ITEM 6. SECTION 96(2) APPLICATION: 115-119 BATHURST STREET SYDNEY**FILE NO: D/2013/554/A****DEVELOPMENT APPLICATION NO: D/2013/554/A****SUMMARY****Date of Submission:** 24 December 2013**Applicant:** Greenland (Sydney) Bathurst Street Development Pty Ltd**Architect:** BVN Donovan Hill / Woods Bagot**Developer:** Greenland (Sydney) Bathurst Street Development Pty Ltd**Cost of Works:** \$0

Summary: The application is a Section 96(2) modification to amend a Stage 1 consent for a new retail, residential and hotel development approved on 5 November 2013. The application seeks consent to amend the approved building envelope and alter or delete a number of conditions attached to the Stage 1 approval as 'design development' of the project has progressed. A separate and concurrent Stage 2 application has been lodged and the amendments to the subject Stage 1 will allow both applications to 'align' in terms of the siting of the proposed new building.

Figure 12: Typical floor plan showing changes between approved and proposed building envelopes

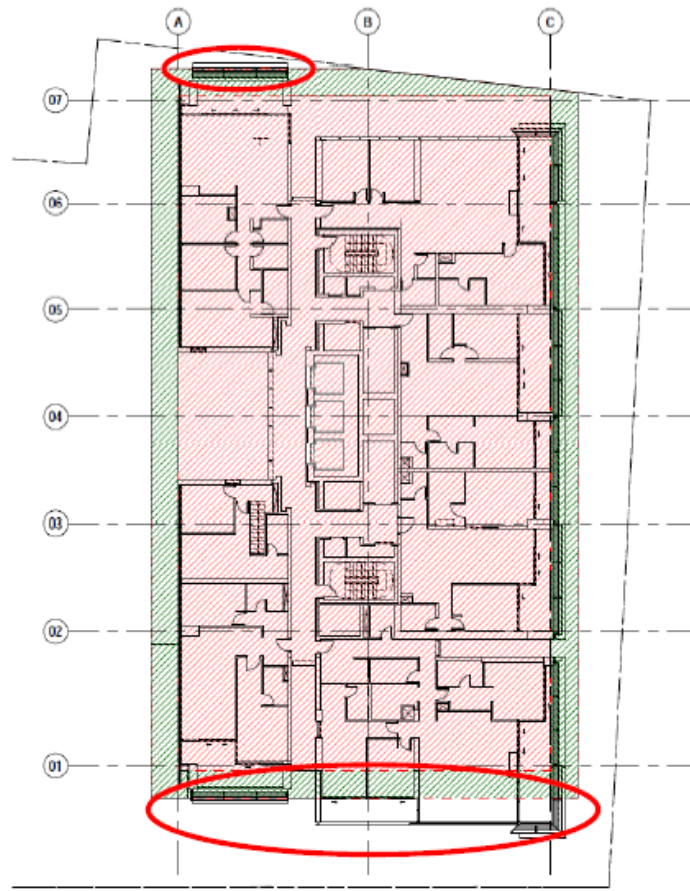
17. The changes proposed to the building envelope are:
 - (a) to shift the building in an eastwards direction on part of the high-rise component of the development (being levels 25-66) up to 3.1m. This will reduce part of the setback from Pitt Street which was approved at 6.1m (see **Figures 12 and 13**);
 - (b) to alter the setbacks on the western edge for that part of the high-rise component of the development (being levels 25-66) such that these will range between 0.1 and 5m (setbacks between 0.3 and 3m approved). This will increase part of the setback to this side of the tower (see **Figure 12**);

- (a) Following 'design development' and the conclusion of the competitive design process that occurred after approval of the Stage 1 consent, the position of the tower above levels 25-66 has altered. The result of this is that the building now 'intrudes' into the previously proposed eastern setback (6m) by up to 3.1m. At the same time, the western setback (proposed at between 0.3-3m) will increase to 5m in places. However, some of the balconies proposed on the western façade will intrude beyond the zone of the approved building envelope by approximately 450mm. These balconies are located on the south western corner of the development facing westwards.

- (b) The DCP requires tower setbacks that are an average of 8m with a minimum of 6m with side and rear setbacks of 3m. As it is proposed to retain the existing tower structure and build on top of it, the proposed setbacks have, to a large extent, been established by the existing building.

- (c) Whilst the proposed change does not comply with the required DCP setbacks, the applicant has provided both shadow diagrams and perspectives of the tower which demonstrate that the impacts to Pitt Street will be minimal. It is noted that the shift in the position of the tower will only be to levels 25 and above and as such, the change will not be discernible in respect of shadowing impacts or when viewed from the street.

- (d) As the design development of the tower has progressed, the western setbacks have increased. At the time of approval, the proposed setbacks ranged from between 0.3-3m (taking account of the 'angled' boundary profile). The setback of the proposed tower will now range from between 0.1-5m, generally improving the setbacks to that side of the site.

- (e) Whilst again, this does not comply with the required setbacks, these have generally increased from the original proposal. Furthermore, the 0.1m setback will be to the edge of the structural elements associated with the balconies and the 'trafficable' parts of the balconies will be located 1.4m from the boundary. These setbacks are considered acceptable.

Figure 14: Impact of proposed changes when viewed from Pitt Street looking south (approved – left, proposed – right)

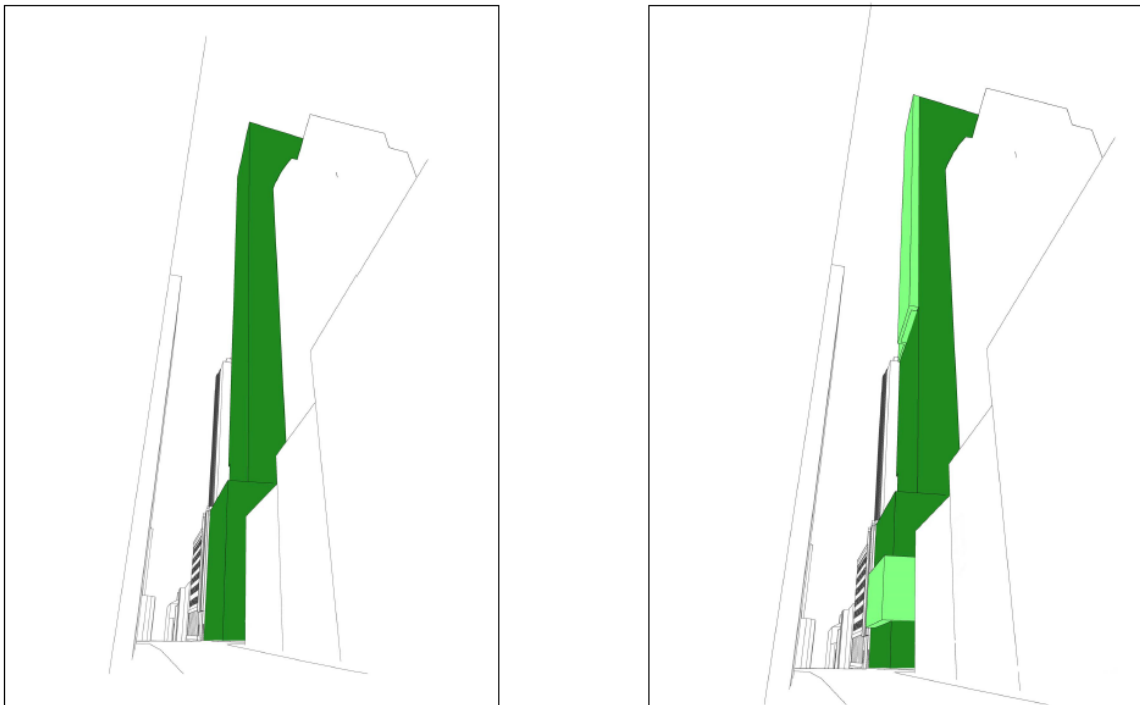
Response – The intrusion into the previously approved setback will be confined to the upper levels of the tower only. At 3.1m this will appear minimal at this elevated level, particularly when the distance between the new building and other surrounding buildings is taken into consideration. Revised shadow diagrams have been provided by the applicant which show this will have a minimal impact.

Figure 15: Detail showing extent of protrusion of balconies beyond approved building envelope (levels 25-66)

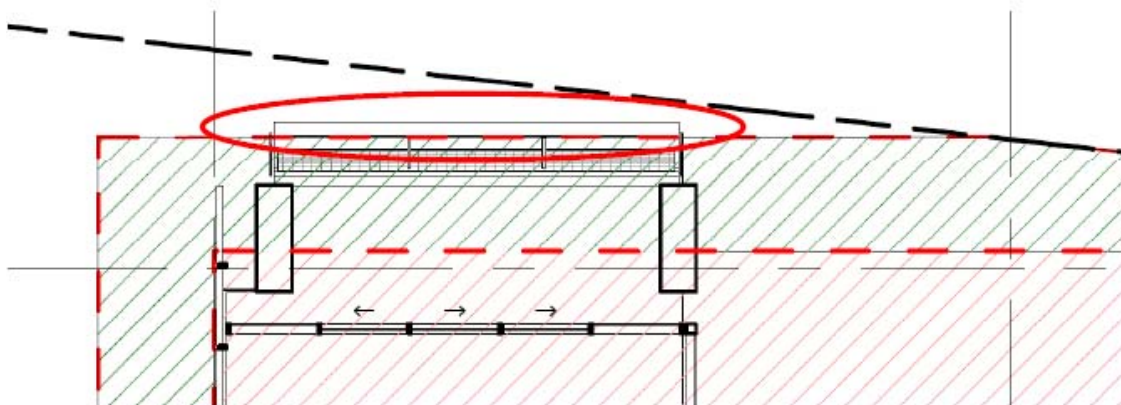
- (c) minor intrusion of the balconies on the high-rise (levels 25-66) component (see **Figure 15**);
- (d) introducing an overhang to Pitt Street (2.3m projection along a length of 23m) and Bathurst Street (1-1.8m projection along a length of 18m) across three storeys (levels 2-4) (see **Figure 16**);
- (e) extending the western side of the podium to the property boundary (see **Figure 17**); and
- (f) the inclusion of a rooftop terrace to the 1939 building.

Figure 16: Plan showing extent of overhang to Pitt and Bathurst Streets (shown clouded) on levels 2-4

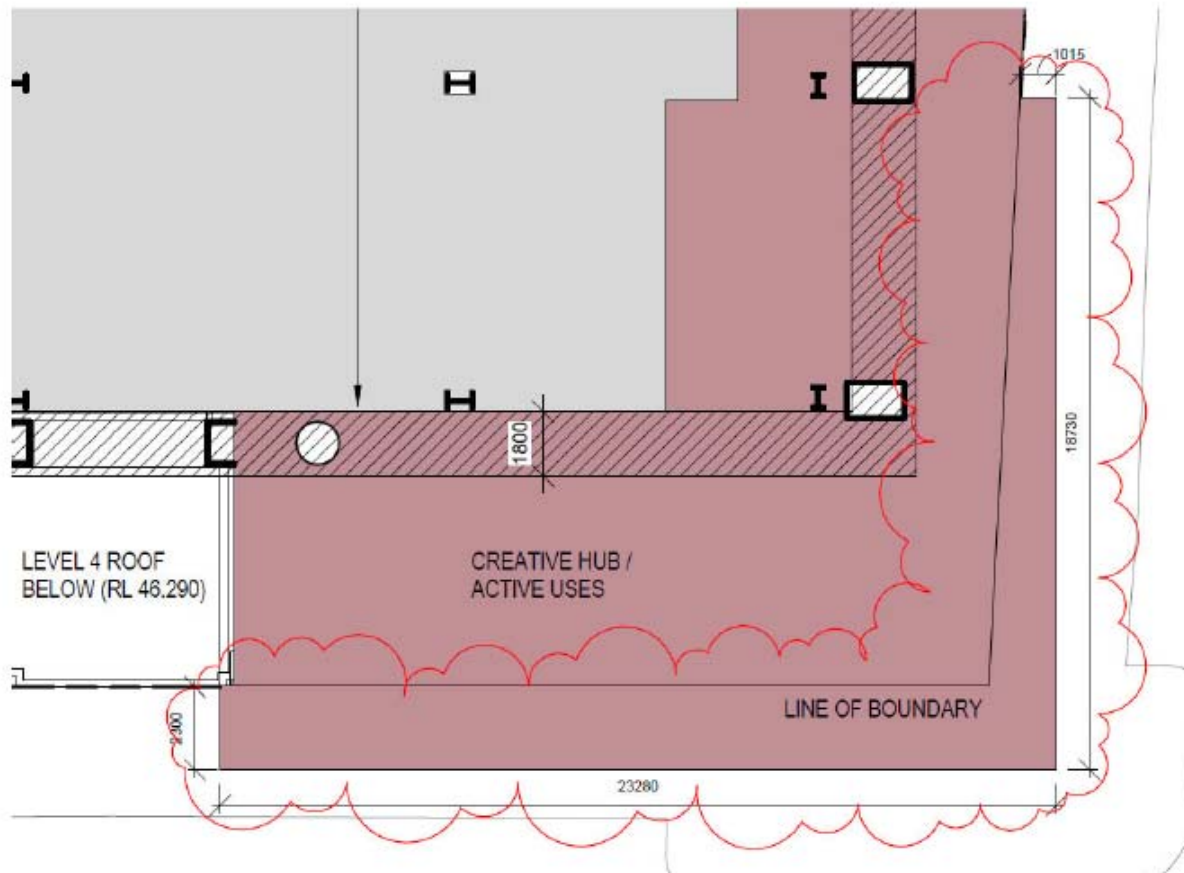
- (f) The proposed overhang to Pitt and Bathurst Streets will project a maximum of 2.3m from the property boundary. As it is proposed to erect awnings around both the Pitt and Bathurst Street frontages above ground floor level, the appearance of a projection will be reduced. The proposal is considered to comply with the provisions contained within Schedule 4 of the *Sydney DCP 2012*.

(d) The overhang to Pitt Street will have an unacceptable visual impact and could create a precedent.

Response – The visual impact of the overhang is discussed above. Any future applications for similar building overhangs will be considered on their individual merit.
